RE: Natomas Crossing - Quadrant B Office (P8-014)

WALKSacramento has reviewed the project routing for Natomas Crossing - Quadrant B Office (P8-014). The project proposes to construct 1,250,000 square feet of office space, a 17,160 square foot daycare center, parking for 6,375 autos, of which 1,904 would be in a multi-story garage, parking for 327 bicycles, and a Class I bike path on two EC-50 parcels and one SC parcel comprising Quadrant B of Area #3 of the Natomas Crossing PUD. The project includes five multi-story office buildings and a single-story private daycare building.

Figure 1

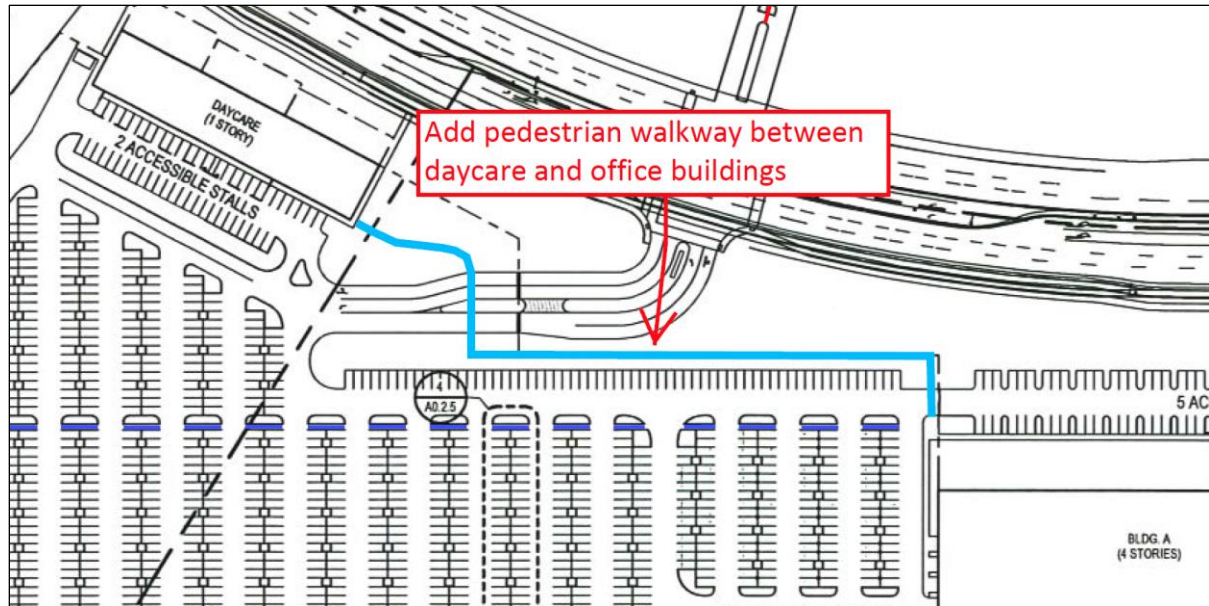
- Add a pedestrian walkway between daycare building and office buildings that minimizes exposure to vehicle movements to provide safe and convenient walking route for staff and parents.

Locating the daycare building at a far corner of the project site will contribute to parents parking in front of the daycare for drop off and pick up, and parking in another spot that is more convenient to their work location. This will generate more automobile circulation in the parking lot and more cold or warm engine starts. A walkway in the landscaped area between the parking and East Commerce would provide a safer and more convenient walking route. Note that the walkway crosses the entry/exit driveway in two stages so only one direction of traffic is confronted by the pedestrian. See Figure 1.

Figure 2

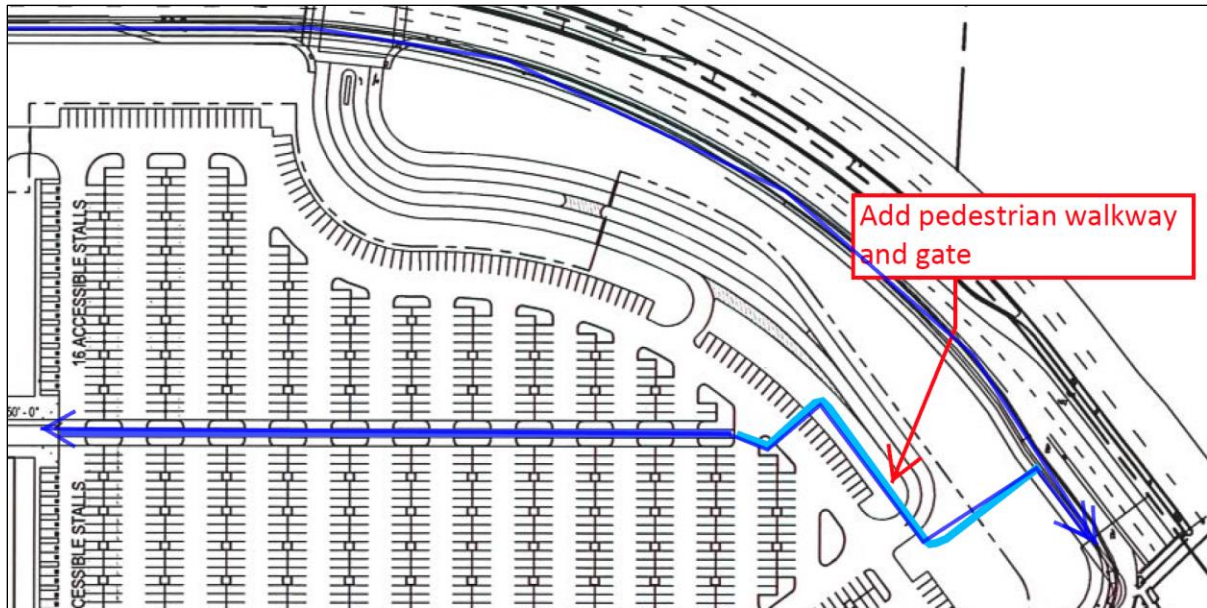
- Add a pedestrian walkway between Building B and intersection of East Commerce and Arena Boulevard that minimizes exposure to vehicle movements to encourage walking to and from nearby residential and retail.

The southwest corner of East Commerce Way at Arena Boulevard is almost directly in line with the Quad B Office linear courtyard and pedestrian walkway through the south parking lot. However, the proposed pedestrian route from the corner requires travelling over 2000' to get to the lobby, whereas if a pedestrian gate was added near the corner, the distance to the closest building entrance would be about 800' shorter.

Minimizing the distance to the corner is important because of the destinations beyond the intersection will be attractive to employees. There's a neighborhood shopping center diagonally across the intersection of East Commerce Way at Arena Boulevard, and the other two corners will have restaurants, retail and commercial in the future. In addition to the land uses on the corners, there will be pedestrian trips from/to nearby residential located to the south and southeast. See Figure 2.

Figure 3

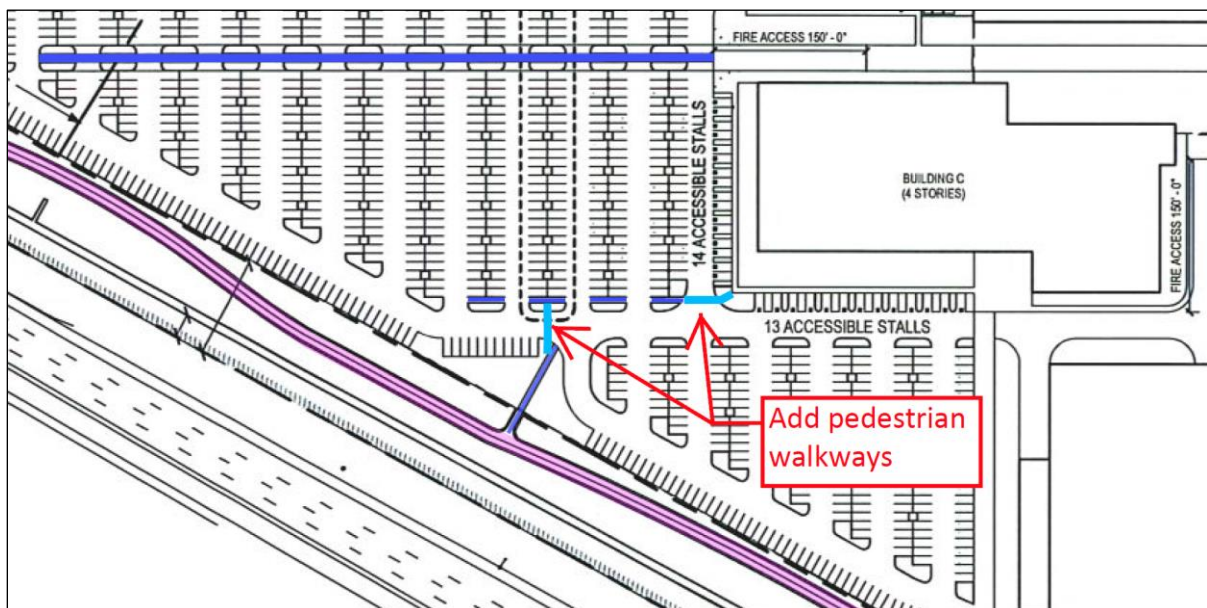
- Add a pedestrian walkway between Building C and the bike path to encourage employees to take walks during, before and/or after the workday.

The project drawings show a 6' sidewalk and pedestrian gate between the bike path and the parking lot northwest of Building C. Bicyclists will use the parking lot drive aisles to access the on-site bicycle parking and the sidewalk to the bike path, but pedestrians should have a dedicated walkway. See Figure 3.

Figure 4

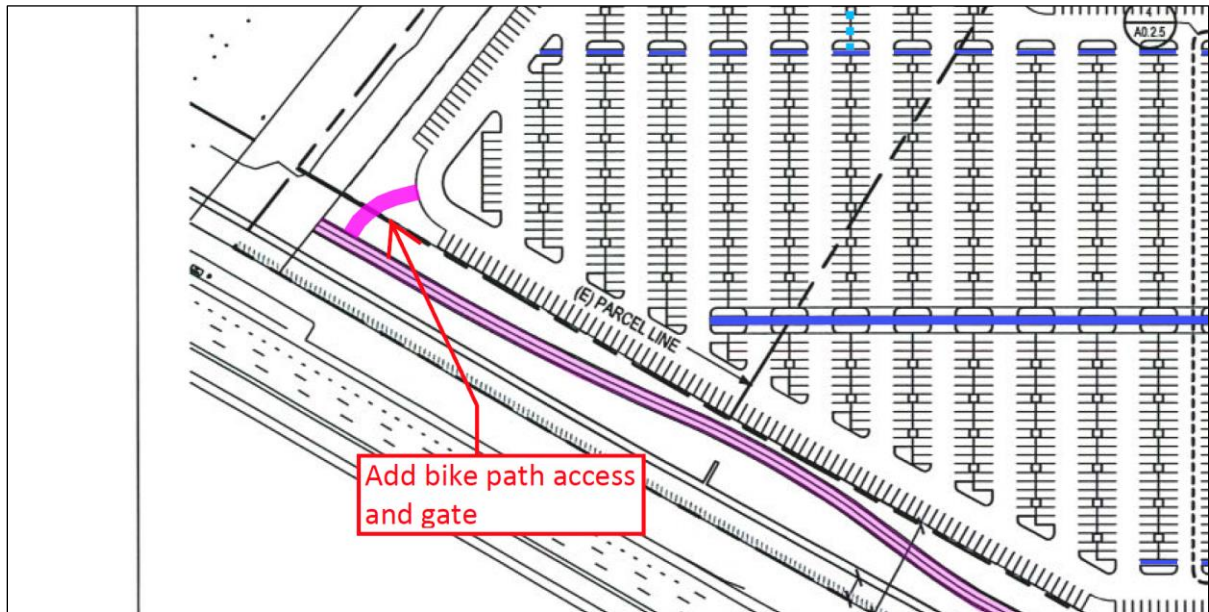
- Add a bike path access to project site near the northwest corner of site to provide a convenient route to the daycare building for employees wanting to bike to work.

The bike path at the northwest corner of the project site will connect to the planned Snowy Egret overcrossing and the continuation of the bike path along the freeway up to Del Paso Road. These will be important routes providing primary bicycle access to residential on the west side of I-5 and the commercial at Del Paso Road and the residential north of Del Paso Road. See Figure 4.

Figure 5

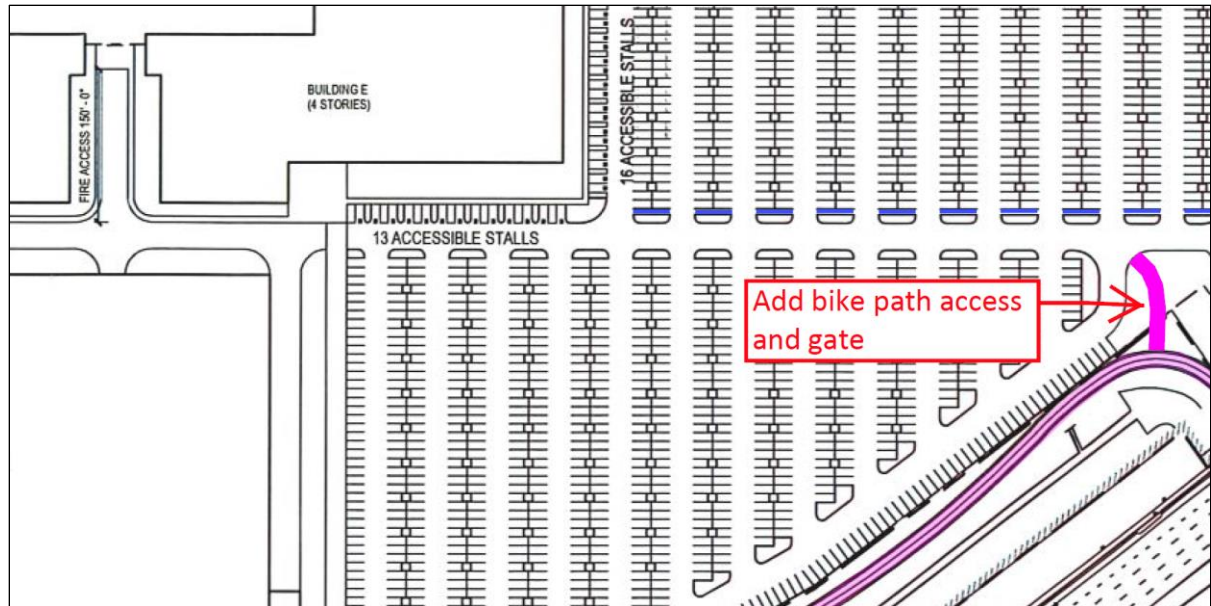
- Add bike path access to project site near the bike path's 90° turn where the maintenance access from Arena Boulevard connects to the bike path.

Bicyclists that park at the south end of the office buildings and start or end their trips south of the project site may not find the proposed gate to be convenient. Adding bike path access and gate would shorten trip distance and be more direct for some employees. See Figure 5.

Figure 6

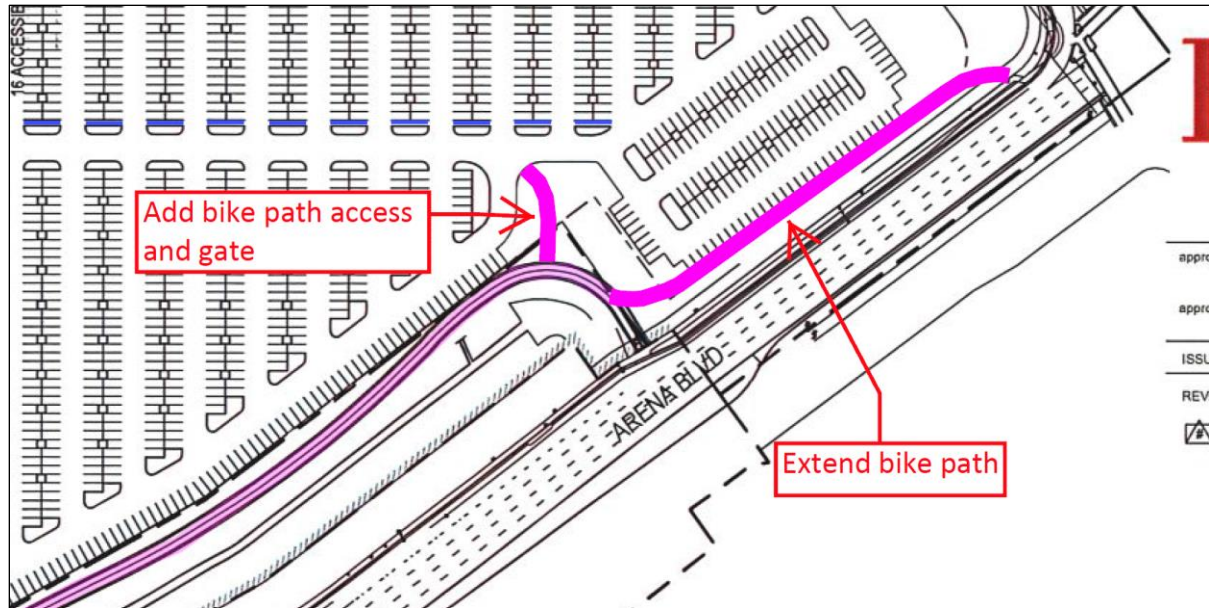
- Extend the bike path to the intersection of East Commerce and Arena Boulevard to allow bidirectional travel and connections to bike lanes on East Commerce and Arena Boulevard and the future freeway buffer bike trail south of Arena Boulevard.

Connecting the bike path to Arena Boulevard at the proposed location - where the existing maintenance access curb cut at the beginning of the I-5 on ramp - will be unsafe for several reasons: the speed limit is 45 mph, only a westbound bike lane is available for bicyclists, eastbound bicyclists will have only the sidewalk available to them and some eastbound bicyclists may go the wrong direction in the bike lane.

Extending the bike path to the corner will allow bicyclists to access signalized crossings of Arena Boulevard and East Commerce Way, and allow safe and legal travel in all directions rather than only to the west. Conflicts with pedestrians will also be minimized. In addition, the bike path terminus on Arena Boulevard is at the corner in the City of Sacramento Bicycle Master Plan. See Figure 6.

Figure 7

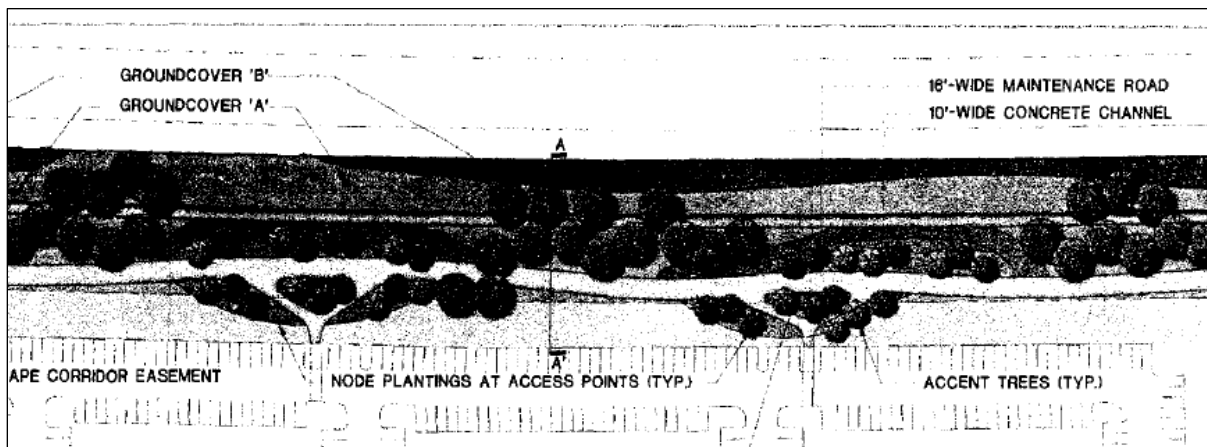
The two diagrams below are taken from the North Natomas Landscape Corridor Guidelines. We highly recommend that the Natomas Crossing Quadrant B Office bike path incorporate the illustrated design elements, including trees on both sides of the path, and significant setback distance of parking areas from the bike path. See Figures 7 and 8.
